Appendix B: Agency Correspondence

To: CJV
 From: LINK427 Design Team
 Title: Pond-2 Outlet Relocation

Date: Thursday, June 27, 2019
 No. MEMO-250 R1

**Re: Pond-2 Outlet and Drainage Feature Technical Memo
Highway 427 Extension Project
GEO Morphix Project No. PN17022**

Figure 1 - Pond-2 Outlet Original and Proposed Location

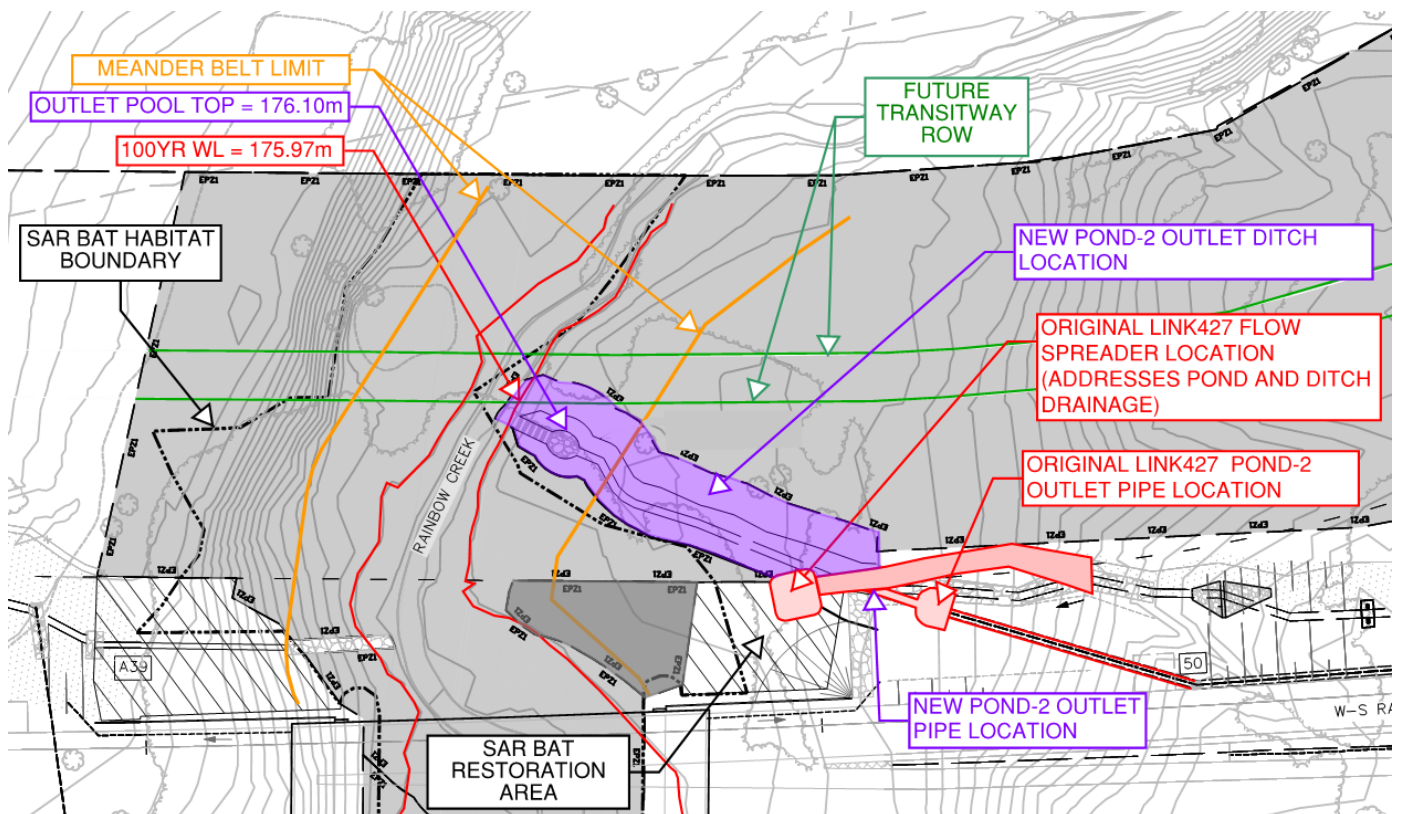
This memorandum has been prepared to identify that there has been a change to the location of the Pond-2 outlet, the reasons for the outlet relocation and the implications on potential impacts to the environment and on future infrastructure due to the new location of the outlet.

In the design presented in DCR#4 (original LINK427 design), the outlet pipe from Pond-2 discharged to a plunge pool as shown in blue in **Figure 1**. From there, runoff was conveyed by a swale to a flow spreader shown in red in **Figure 1**. From the flow spreader, runoff was to sheet flow over vegetated surfaces, ultimately discharging to the creek. Subsequently, the 3D surface modelling for the outlet area was refined and it revealed that positive drainage could not be provided with the original outlet configuration. In order to provide positive drainage, the flow spreader would have to be relocated at a lower elevation and be moved within the EPZ2 (shown in dark grey in **Figure 1**) and within Species at Risk (SAR) bat habitat (SAR bat habitat boundary depicted by dashed line in **Figure 1**), which was not a feasible option, as the flow spreader would have been a permanent disturbance in an area (EPZ2) where only temporary disturbance is allowed. After multiple design iterations and multidisciplinary review, it was concluded that the optimal location would avoid the SAR bat habitat, the Future transitway right of way and the EPZ2 area. This optimal location is highlighted in purple in **Figure 1**.

As shown in **Figure 1**, the outlet pipe from Pond-2 will still discharge near the original location. Runoff will then be conveyed via a bio-swale, which directs flows to a pool at the base of the slope for increased flow retention and infiltration. Both the bio-swale and pool are lined with a mix of soil and granular materials (e.g., river stone) and covered with a biodegradable erosion control blanket (see attached stormwater management details, DWG 2213). Additionally, a high density of live staking is proposed throughout to enhance the stability of the feature through root generation. During periods of high flow, runoff will be guided downstream of the pool through a series of wattles, which will act to further regulate flows near the creek. The wattles will consist of bundles of live woody debris bundles, which should be sourced on-site, where possible. Additionally, based on input from the fluvial geomorphologists, the placement of the drainage feature has been intentionally situated away from any immediate channel meanders. A level of lateral migration is expected over the long term beyond 100 years but it is not considered significant. Bio-swale details have been included in the attachment (Stormwater management details, DWG 2213). It is worth mentioning that the relocation of Pond-2 outlet was not caused by nor will impact Pond-2 hydrology or hydraulics. Further details relating to hydraulic of the bioswale and outlet design as well as implementation and restoration recommendations are described in the Pond-2 Outlet and Drainage Feature Technical Memo by Geo Morphix attached.

Figure 2 - Future Transitway Preliminary Plan and Profile

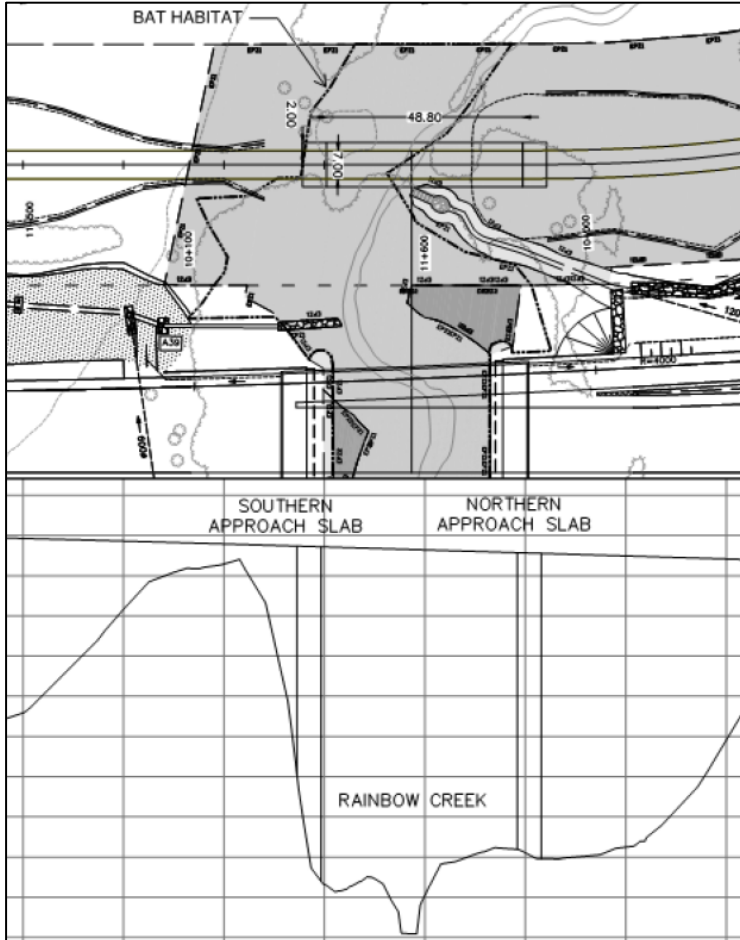
An analysis was completed to demonstrate that the future Transitway construction will not be impacted by the proposed Pond-2 outlet ditch into Rainbow Creek. **Figure 2** shows a preliminary plan & profile of a potential future Transitway bridge over Rainbow Creek with a similar profile and span configuration as the Highway 427 bridges. The preliminary grading lines shown indicate that there is adequate room for conventional construction of the bridge approach and grading treatments surrounding the future abutments, with no additional work to be performed by the CA. The outlet can be relocated in the future if deemed necessary.

TITLE							
HWY 427 EXPANSION TEMPORARY DETENTION BASIN AND ROB-1 CROSSING							
PROJECT ID.	STAGE IDENTIFIER	DESIGN PACKAGE NUMBER	DISCIPLINE	STRUCTURE NUMBER	DOCUMENT TYPE	DRAWING NUMBER	REVISION NUMBER
H427-D	N	7	WAT	000	DWG	2200	A

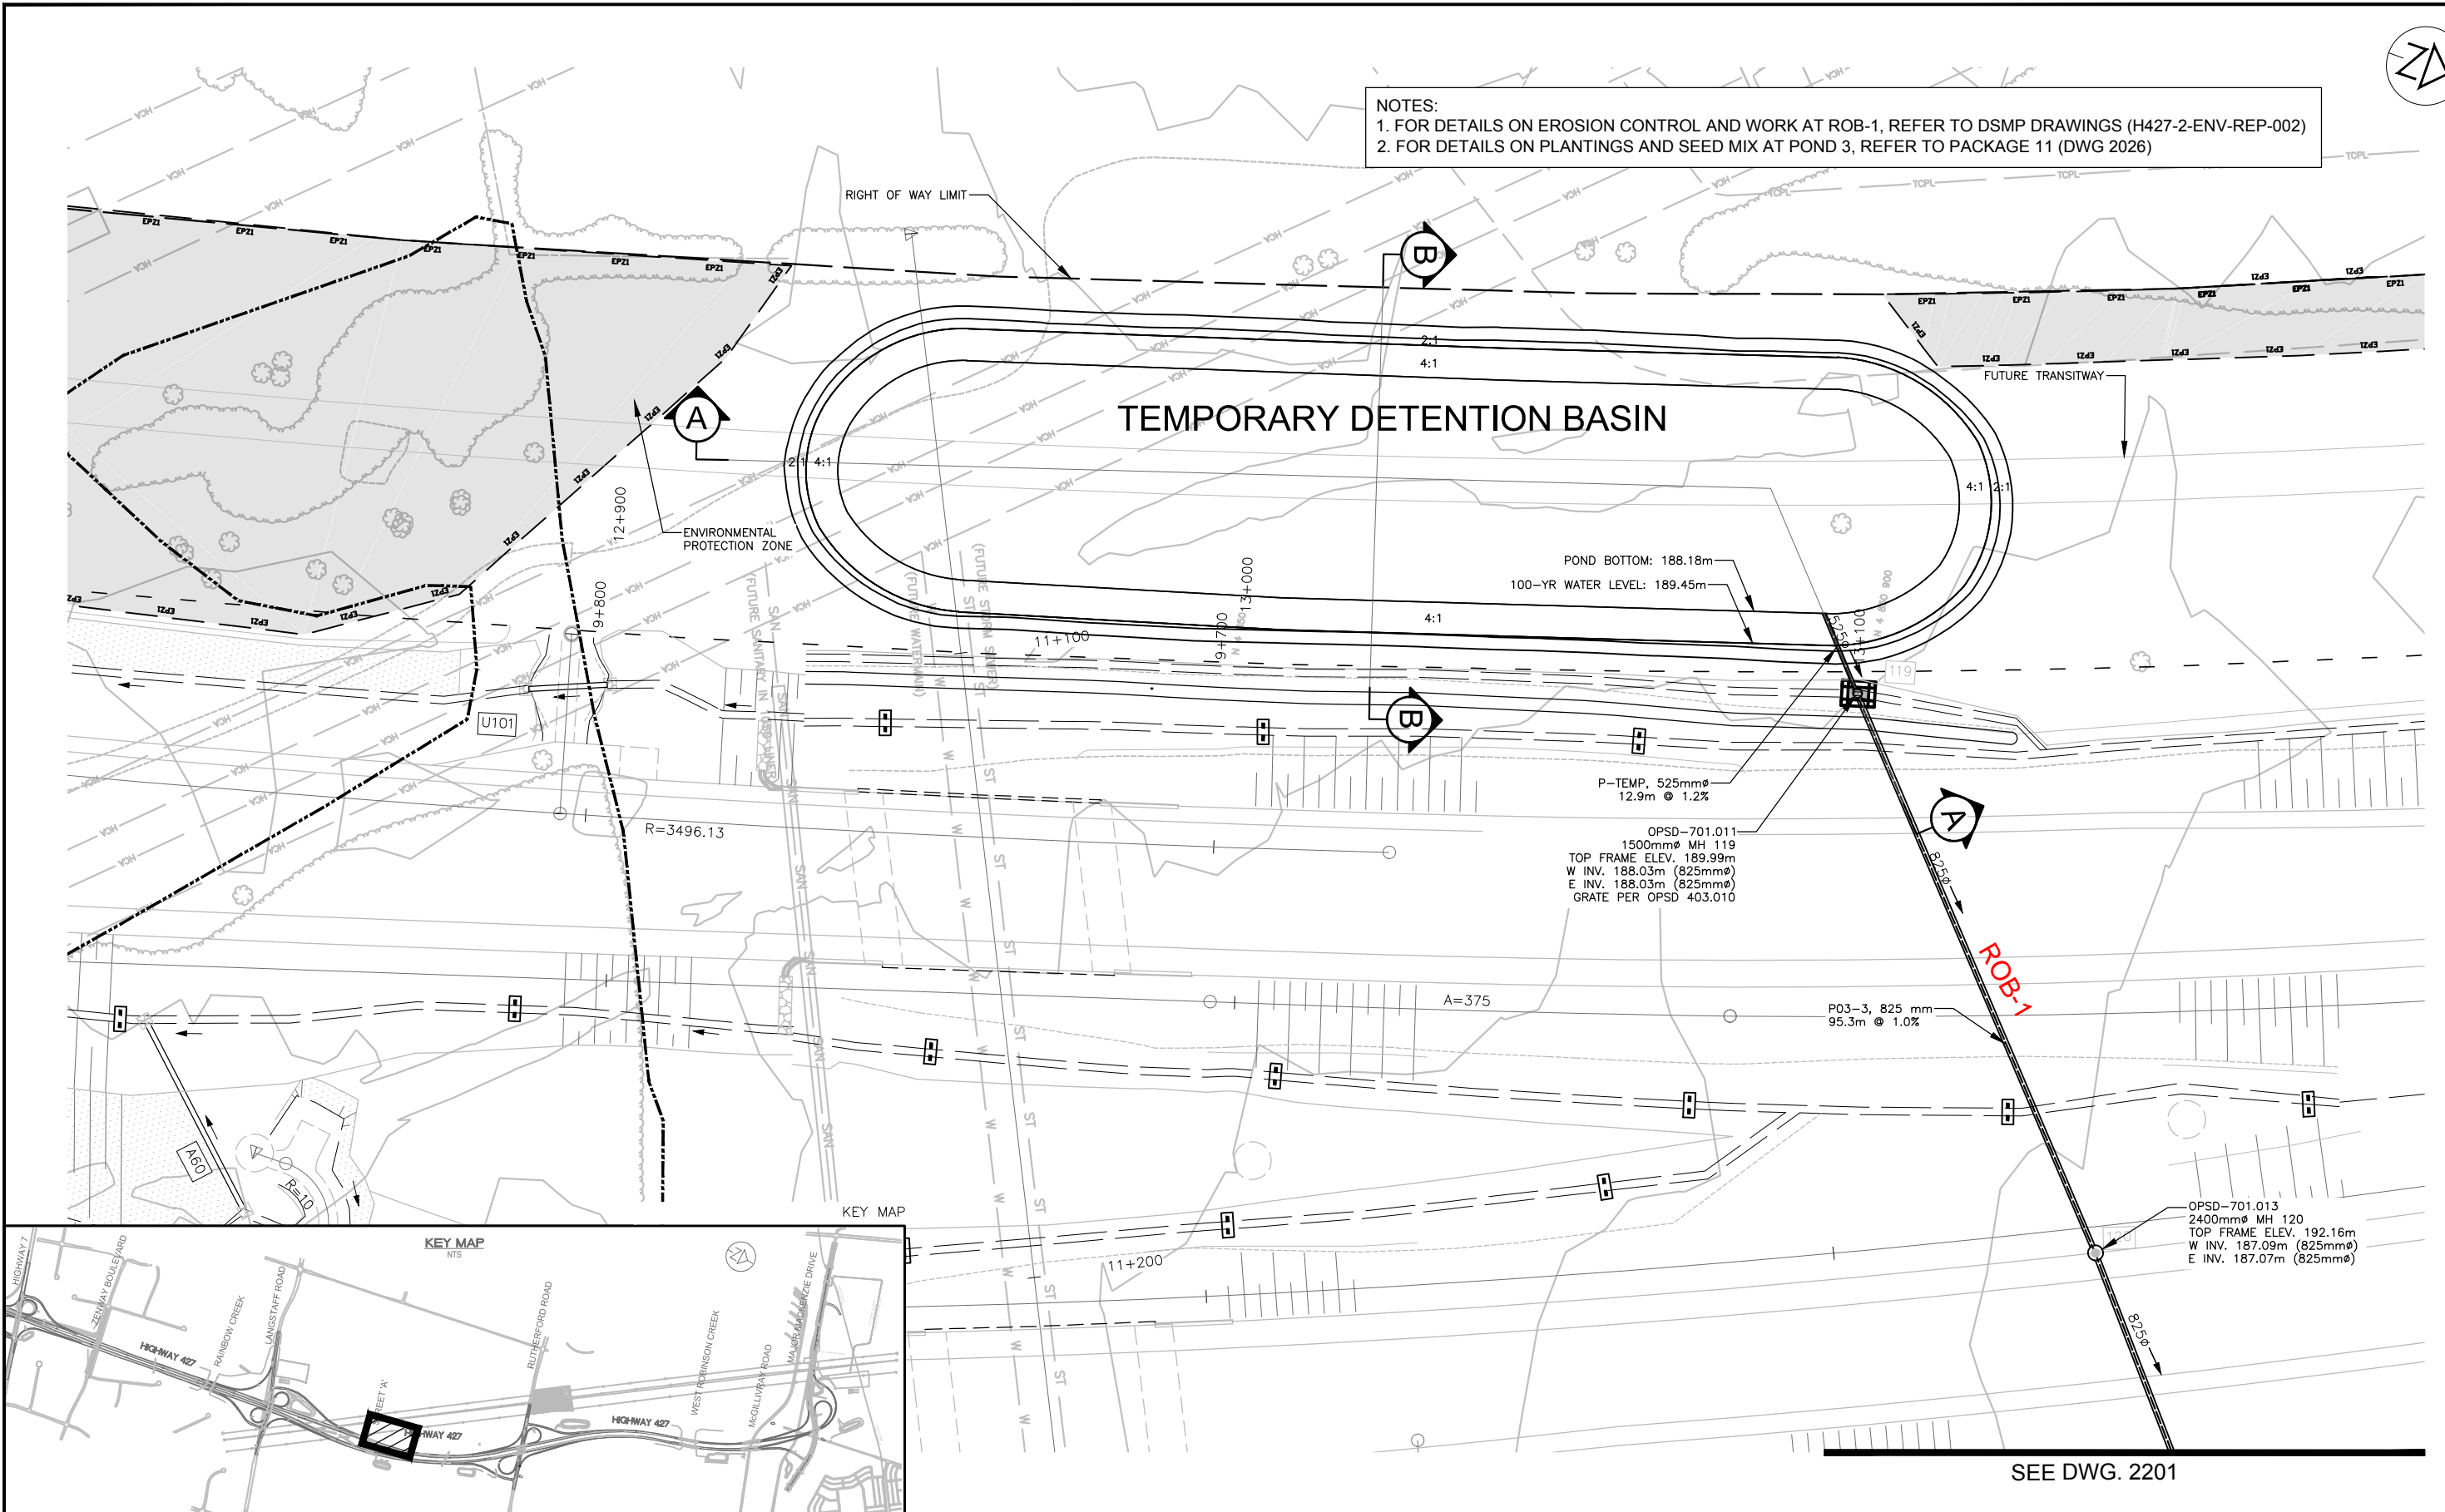
This interim solution will consist of a retention basin located on the west side of the highway alignment upstream of ROB-1 to temporarily store runoff from the ROB-1 catchment area (see DWG-2200). A 525 mm sewer will be placed at the retention basin outlet and will discharge to the proposed Ditch Inlet Manhole (DIMH-119), which will be equipped with a 275 mm orifice plate placed at the upstream end of ROB-1 to control release rates. Additionally, the Pond-3 outlet design has been modified to over-control release rates so that the sum of flows at ROB-1 and Pond-3 outlet match pre-development peak flows (see **Table 1** for more details). Location details of the temporary retention basin and DIMH-119 structure are included DWG 2200 in the **Attachment**. The temporary retention basin will be seeded with a cultural meadow mix, and SWM pond seed mix for enhancement and erosion control.
